PLAN REVIEW SHEET

2015-096

FCD-Development, LLC

Attachments: Bus stop pad detail

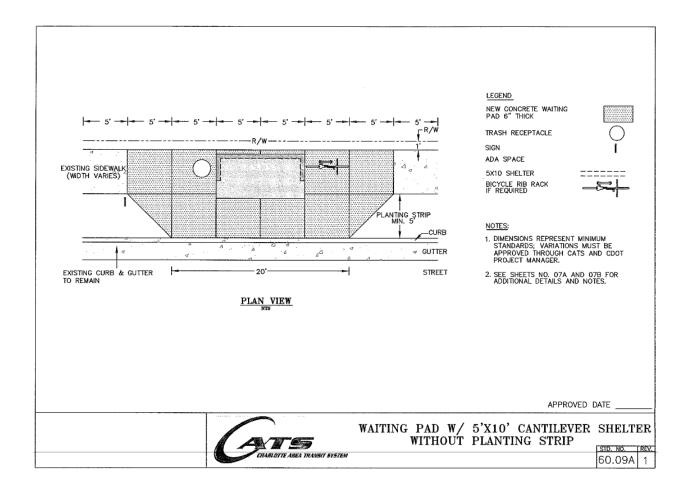
This site is located near an existing bus stop on East Seventh Street. The Petitioner is requested to provide and construct a bench pad for a relocated bus stop on East Seventh Street. Below is an image of the standard detail (60.09A) for the requested bus stop pad. Note that the design of the bus stop allows for future conversion to a shelter. A bicycle rack is optional, though it may count towards short-term bicycle parking. CATS will be responsible for installation and maintenance of the bench or shelter.
